ORCHARD GARDENS REDEVELOPMENT
DEVELOPMENT FOR:
FIRST COMMUNITY HOUSING
245 W. WEDDELL DRIVE, SUNNYVALE, CA 94089

100% CONSTRUCTION DOCUMENTS & PERMIT SUBMITTAL
ISSUED ON:
07.14.2025

Misc. Plan Permit - Substantial Conformance Documentation

13
1 STREET FRONTAGE RENDERING - PLANTER/SEAT WALL UPDATES
1/8" = 1'-0"
MISC. PLANNING PERMIT ADJUSTMENT DRAWING

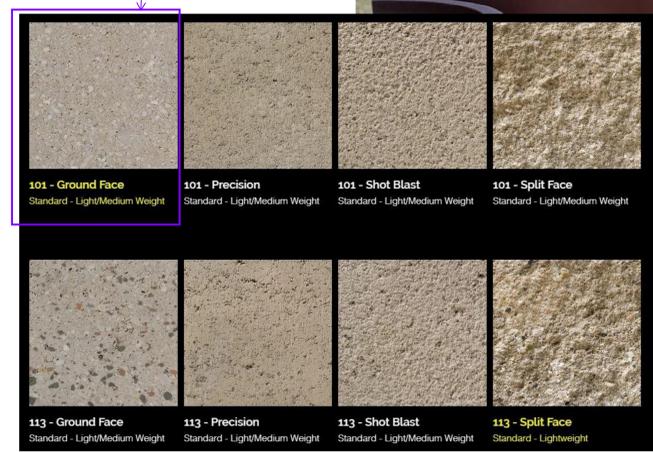
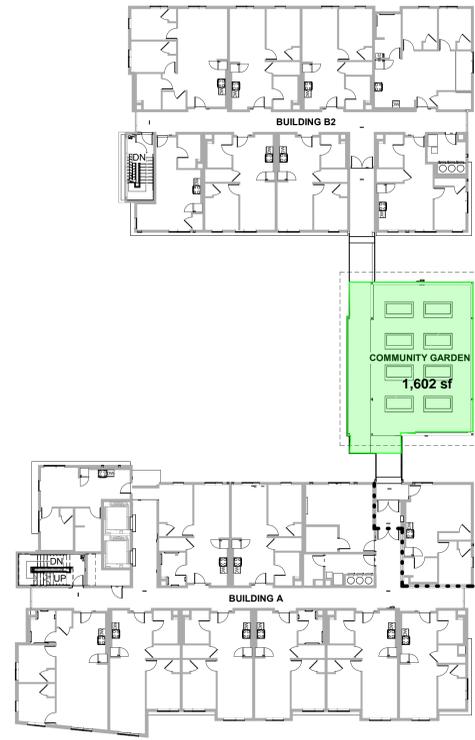
PROPOSED CMU PLANTER WALL MATERIAL, COLOR, STACKING AND CAP FOR RAISED PLANTERS ALONG THE STREET FRONTAGE, PEDESTRIAN CONNECTION AND COURTYARD. THE CMU PLANTER WALLS PROVIDE A DURABLE AND AESTHETICALLY PLEASING SOLUTION ADDING TEXTURE AND COLOR TO THESE AREAS.

SHEET NOTES
13 PLANTER WALL MATERIAL AT FRONT ELEVATION CHANGED FROM WOOD BOARD OVER CONCRETE TO CMU
22 REMOVAL OF DECORATIVE STEEL TRELLIS OVER ROOF GARDEN
